# UNITED STATES PATENT AND TRADEMARK OFFICE

APPLICATION NO.	FILING DATE	FIRST NAMED INVENTOR	ATTORNEY DOCKET NO.	CONFIRMATION NO.
10/603,712	06/25/2003	Minjoo L. Lee	MIT.9889	3454
7590	02/22/2005		EXAMINER	
Samuels, Gauthier & Stevens LLP Suite 3300 225 Franklin Street Boston, MA 02110			WILSON, ALLAN R	
			ART UNIT	PAPER NUMBER
			2815

# Office Action Summary

**DETAILED ACTION*****Drawings***

FIG. 2A

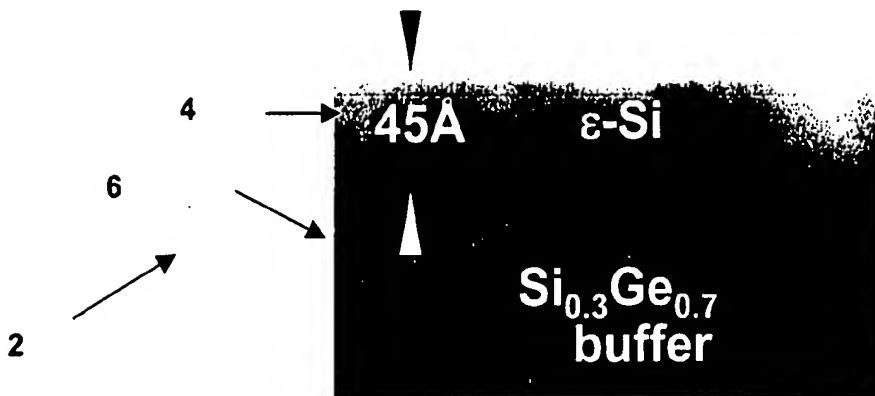
The drawings are objected to under 37 CFR 1.83(a). The drawings must show every feature of the invention specified in the claims. Therefore, the layers forming the MOSFET, PMOS, NMOS and CMOS must be shown or the feature(s) canceled from the claim(s). The drawings are too dark to show the details. No new matter should be entered.

The argument that FIGs. 2A-2B and 3A-3B illustrate a MOSFET is not persuasive. The drawing are too dark to see the construction or elements. Attached are copies of FIGs. 2A-2B and 3A-3B (Exhibit A) that show what was scanned.
